PCN: V20-005-476103-OA

Product Change Notice

- 1) Change unit marking method.

- 1) Part Number:-
 - i. AEDR-9820-100, AEDR-9820-102, AEDR-9830-100, AEDR-9830-102,
 - ii. AEDR-9820A-100, AEDR-9820A-102, AEDR-9830A-100, AEDR-9830A-102
 - iii. AEDR-9920-100, AEDR-9920-102, AEDR-9930-100, AEDR-9930-102
 - iv. AEDR-9930A-100, AEDR-9930A-102

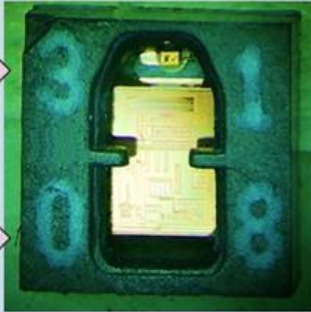
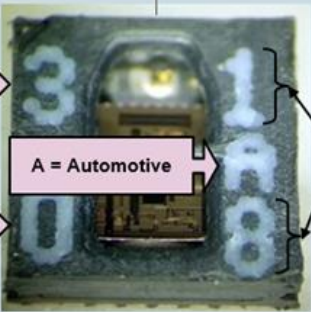
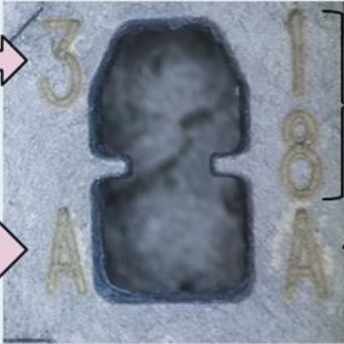
Part Number & Photo			
Item	AEDR-98xx-1xx	AEDR-98xxA-1xx	AEDR-99xx-1xx	AEDR-9xxA-1xx
<p>➤ Before Change:</p> <ul style="list-style-type: none"> ▪ White Ink Marking/ Marking Arrangement 				
<p>➤ After Change:</p> <ul style="list-style-type: none"> ▪ Laser Marking/ Marking Arrangement

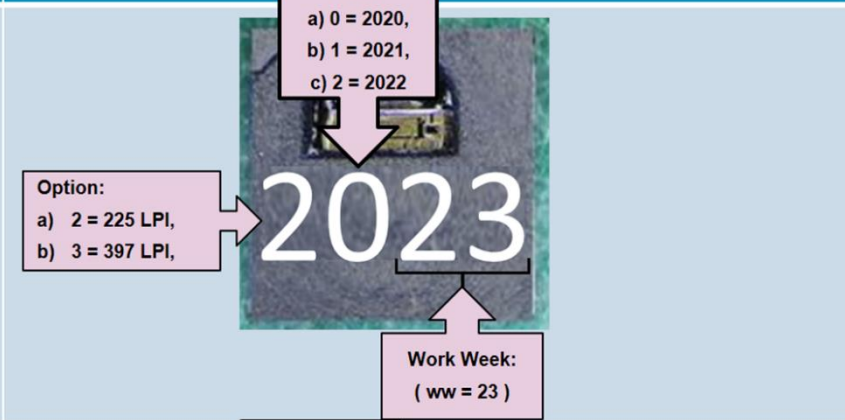
Part Number	Unit Marking Description
<p>AEDR-98xx-1xx (Before change)</p>	 <p>Option: a) 2 = 225 LPI, b) 3 = 318 LPI,</p> <p>Year: a) 0 = 2020, b) 1 = 2021, c) 2 = 2022,...</p> <p>Work Week (ww = 18)</p>
<p>AEDR-98xx-1xx (After change)</p>	 <p>Option: a) 2 = 225 LPI, b) 3 = 318 LPI,</p> <p>Year: a) A = 2020, b) B = 2021, c) C = 2022,....</p> <p>Work Week (ww = 18)</p>

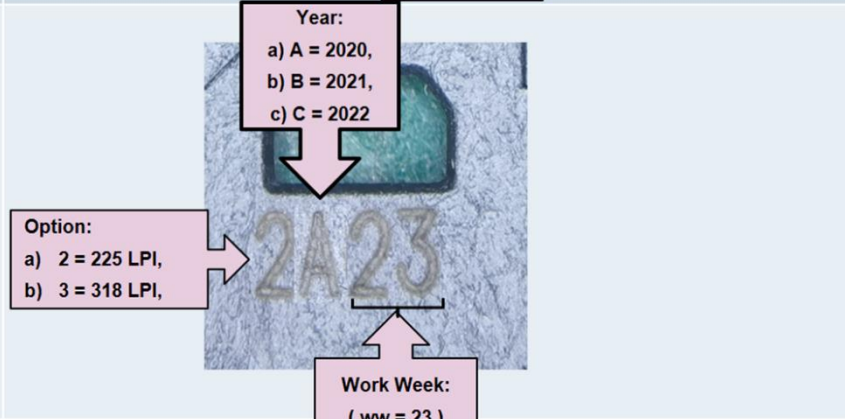
Part Number	Unit Marking Description
<p>AEDR-98xxA-1xx (Before change)</p>	 <p>Option: a) 2 = 225 LPI, b) 3 = 318 LPI,</p> <p>Year: a) 0 = 2020, b) 1 = 2021, c) 2 = 2022,....</p> <p>A = Automotive</p> <p>Work Week (ww = 18)</p>
<p>AEDR-98xxA-1xx (After change)</p>	 <p>Option: a) 2 = 225 LPI, b) 3 = 318 LPI,</p> <p>Year: a) A = 2020, b) B = 2021, c) C = 2022,....</p> <p>Work Week (ww = 18)</p> <p>A = Automotive</p>

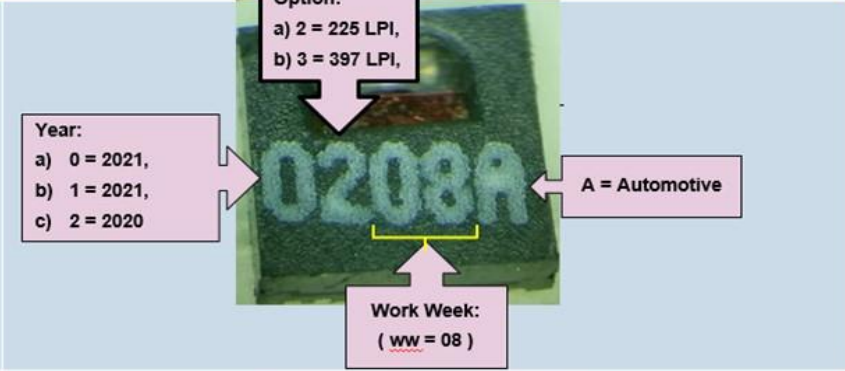
Part Number	Unit Marking Description
<p>AEDR-99xx-1xx (Before change)</p>	 <p>Year: a) 0 = 2020, b) 1 = 2021, c) 2 = 2022</p> <p>Option: a) 2 = 225 LPI, b) 3 = 397 LPI,</p> <p>Work Week: (ww = 23)</p>
<p>AEDR-99xx-1xx (After change)</p>	 <p>Year: a) A = 2020, b) B = 2021, c) C = 2022</p> <p>Option: a) 2 = 225 LPI, b) 3 = 318 LPI,</p> <p>Work Week: (ww = 23)</p>

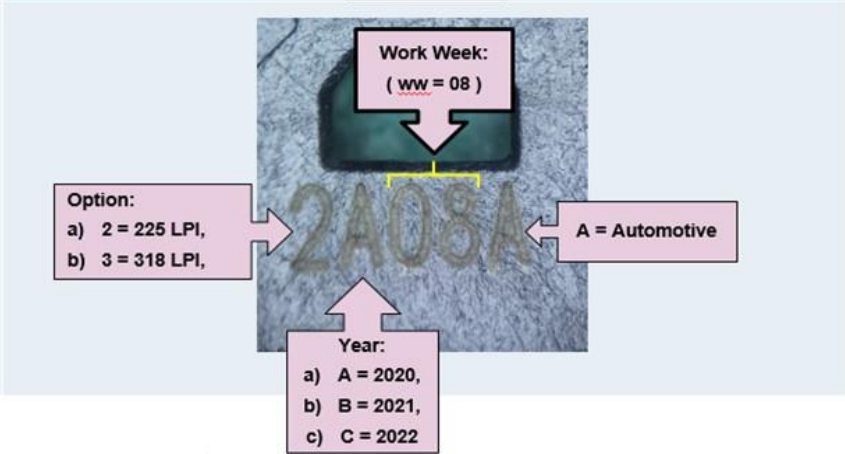
Part Number	Unit Marking Description
<p>AEDR-99xxA-1xx (Before change)</p>	 <p>Option: a) 2 = 225 LPI, b) 3 = 397 LPI,</p> <p>Year: a) 0 = 2021, b) 1 = 2021, c) 2 = 2020</p> <p>A = Automotive</p> <p>Work Week: (ww = 08)</p>
<p>AEDR-99xxA-1xx (After change)</p>	 <p>Work Week: (ww = 08)</p> <p>Option: a) 2 = 225 LPI, b) 3 = 318 LPI,</p> <p>A = Automotive</p> <p>Year: a) A = 2020, b) B = 2021, c) C = 2022</p>
